MEMORANDUM

Project: Dawson Trails

Subject: Roundabout Relocation Request

Figure 1. Location Map

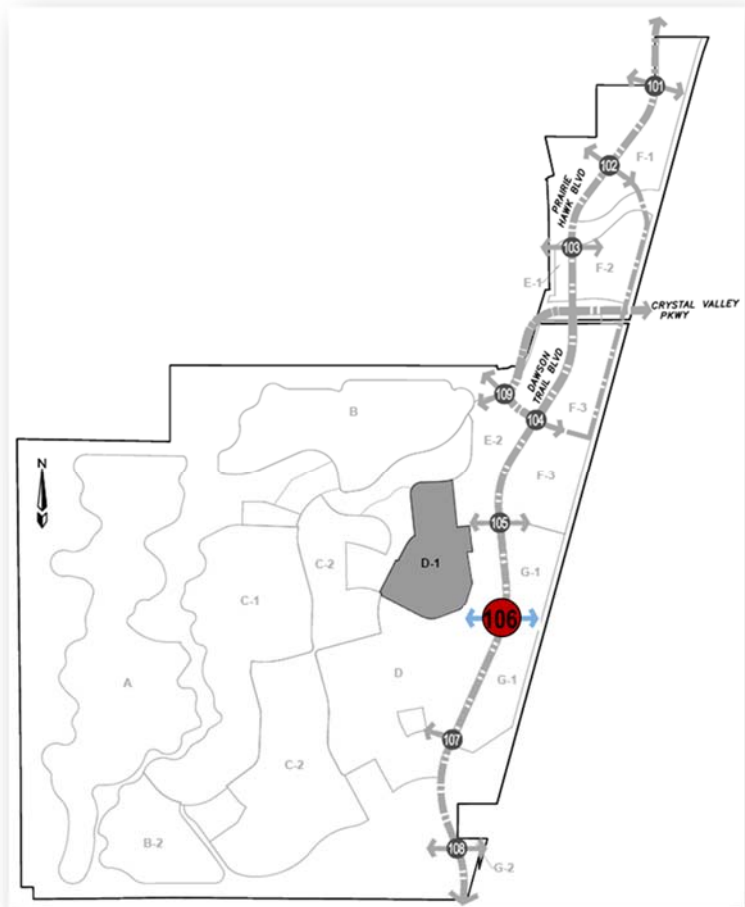
Fox Tuttle Transportation Group has prepared this traffic memorandum and narrative for a request to relocate one of the proposed roundabouts on Dawson Trail Boulevard. The subject intersection is the third full movement roundabout south of Crystal Valley Parkway, which is adjacent to Planning Areas D and G-1a as shown in **Figure 1** (intersection #106).
